Re: Radford Army Ammunition Plant, Va.
Master Work Plan Addendums 020 & 021
Review of the Army's RCRA Work Plan Addendums

Subject: With Certification, Work Plan Addendum 020, RCRA Facility Investigation for Solid Waste Management Units 35, 37, 38 and Area of Concern Q, Final October 2007 and Work Plan Addendum 021, RCRA Facility Investigation at Solid Waste Management Unit 57, Final October 2007
Radford Army Ammunition Plant, EPA ID# VA1 210020730

Response to Comments (8/24/2007)
EPA and VDEQ Comments Received via e-mail 07/06/07
Draft Work Plan Addendum 020, RCRA Facility Investigation for Solid Waste Management Units 35, 37, 38, and Area of Concern Q, Radford Army Ammunition Plant, Virginia, April 2007

SWMUs 37, 38, AND AOC Q
AERIAL PHOTOGRAPH – 1971

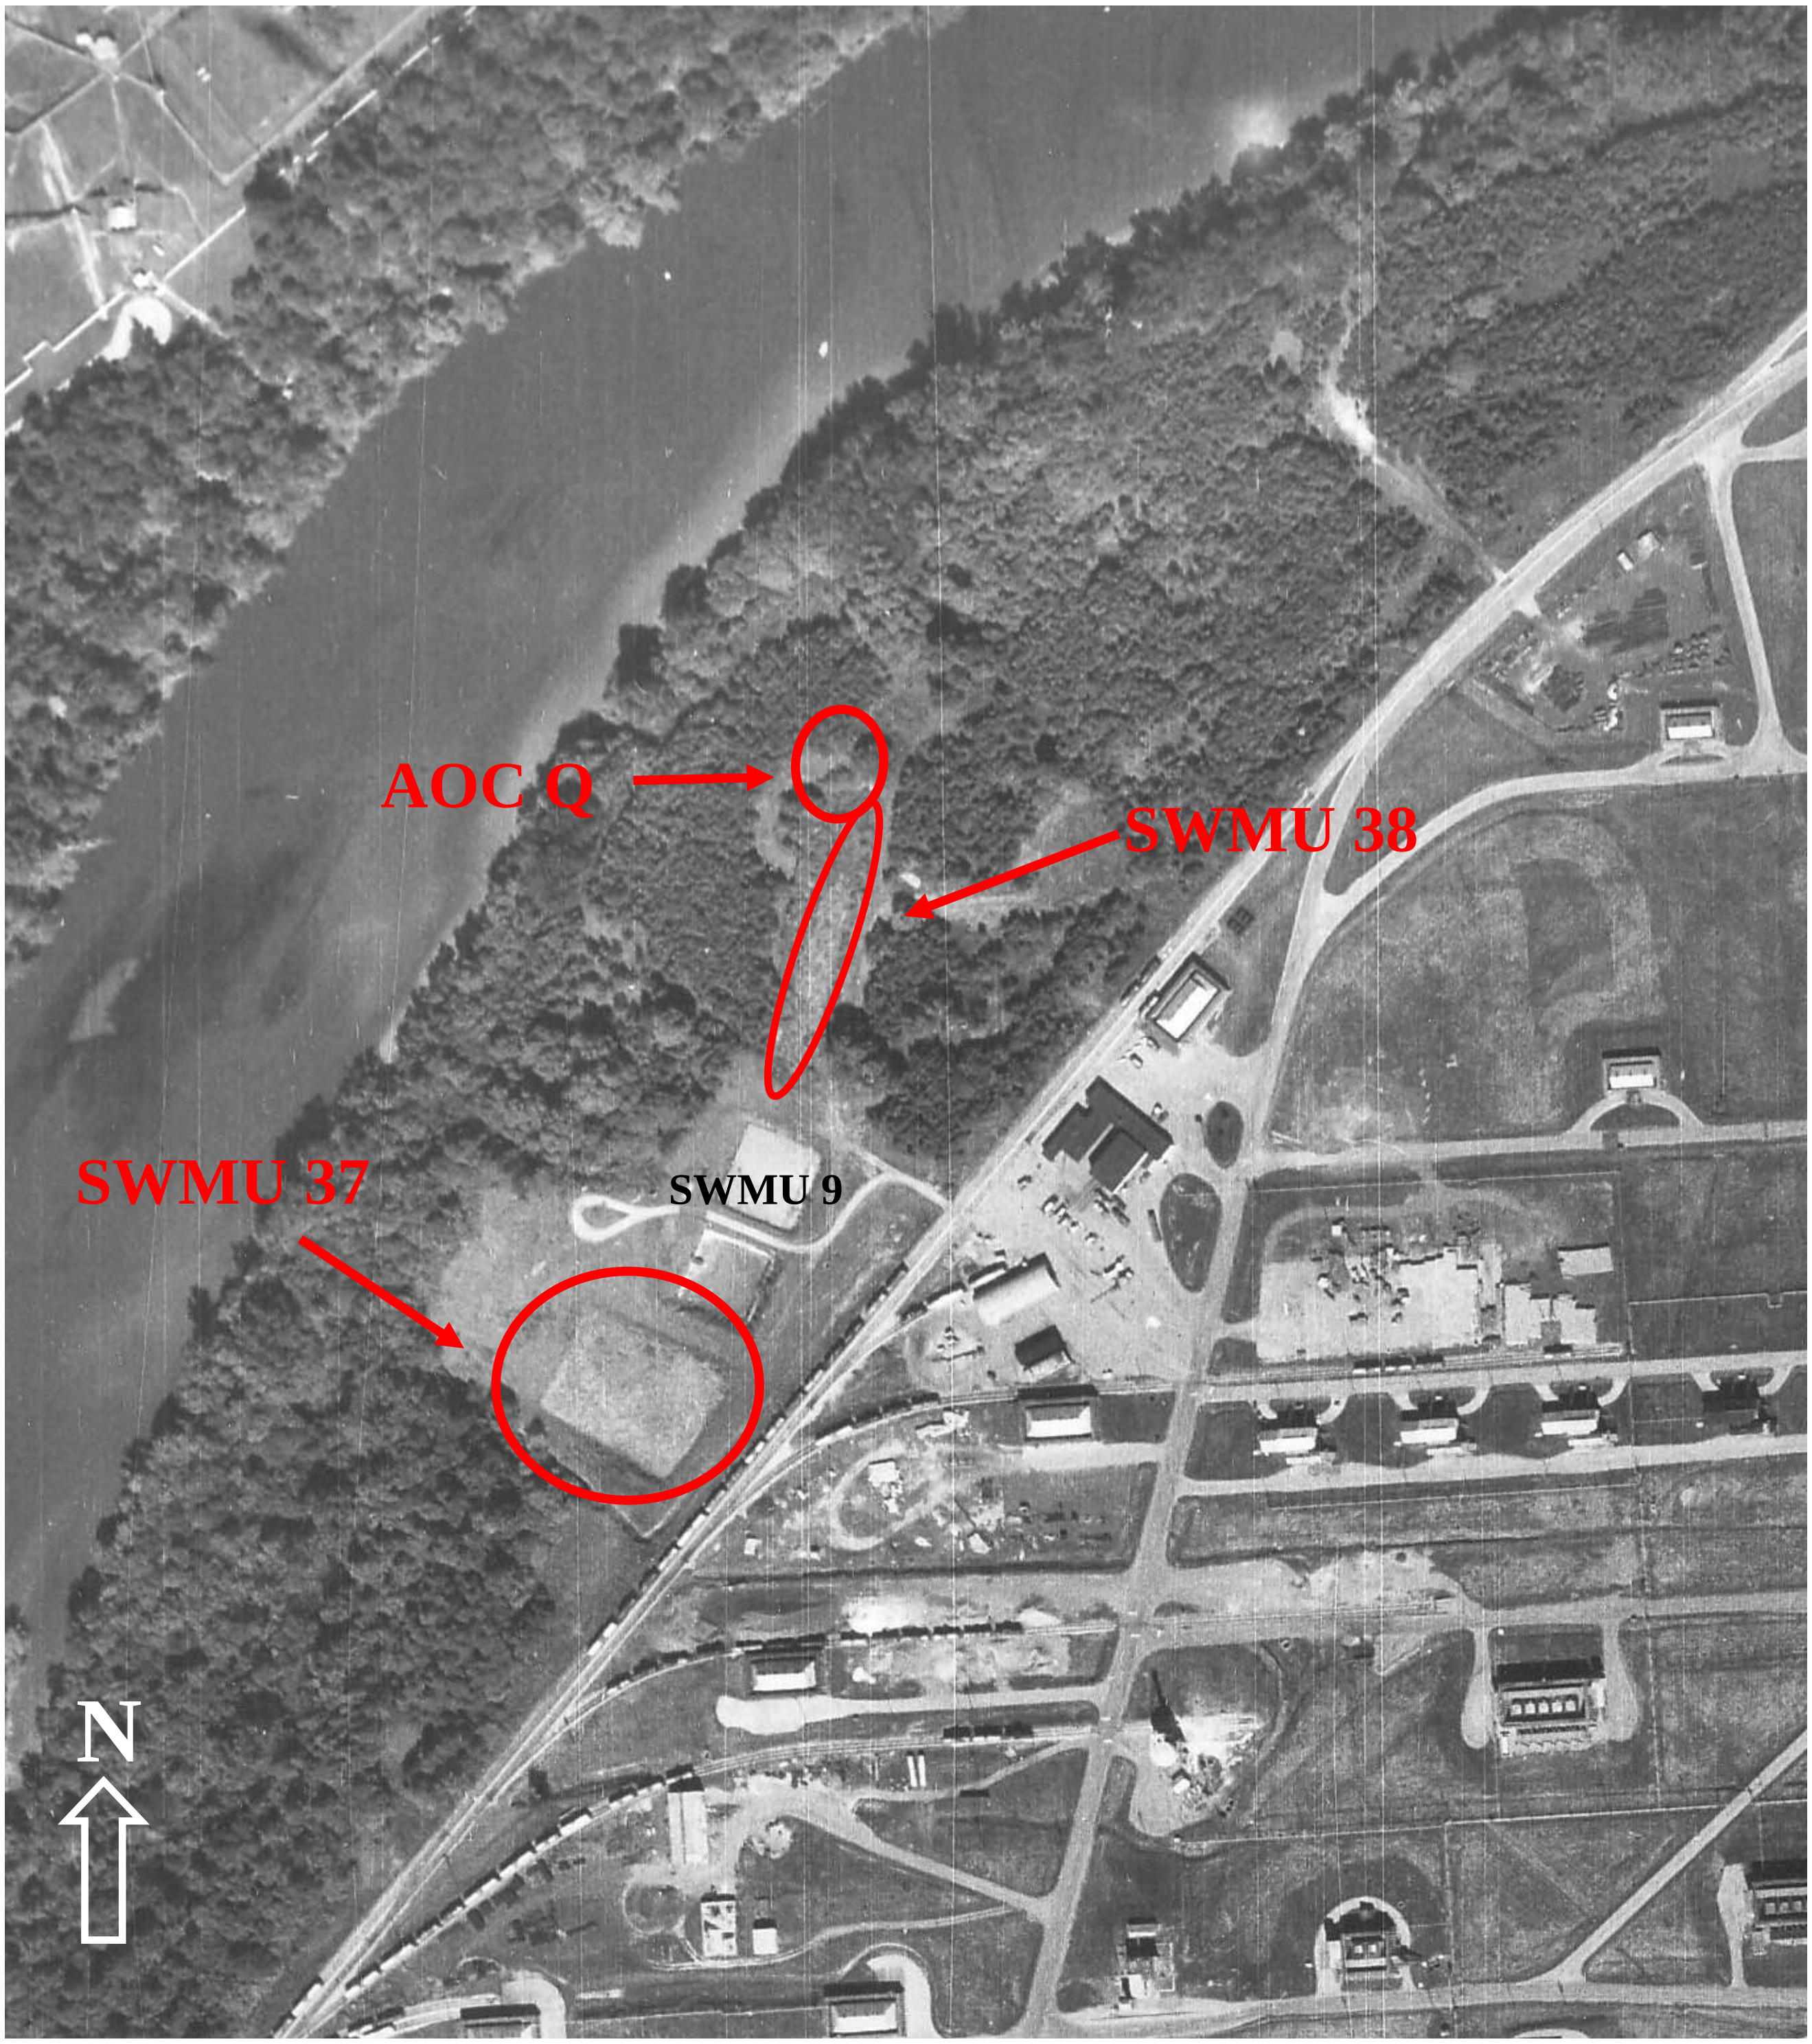
Comment 12: Section 3.3.2, Installation Assessment (Air Photo Interpretation), Page 3-2: This section references only three photographs (1962, 1971, and 1986). It is not clear that any earlier photographs (prior to 1962) were reviewed. Additionally, only the 1962 and 1986 photographs appear to have been attached as figures (Figure 3-3 and Figure 3-4). Please clarify whether photographs prior to 1962 were reviewed, and document the findings of that review, if applicable. Additionally, please revise the Work Plan Addendum to include a copy of the 1971 photograph.
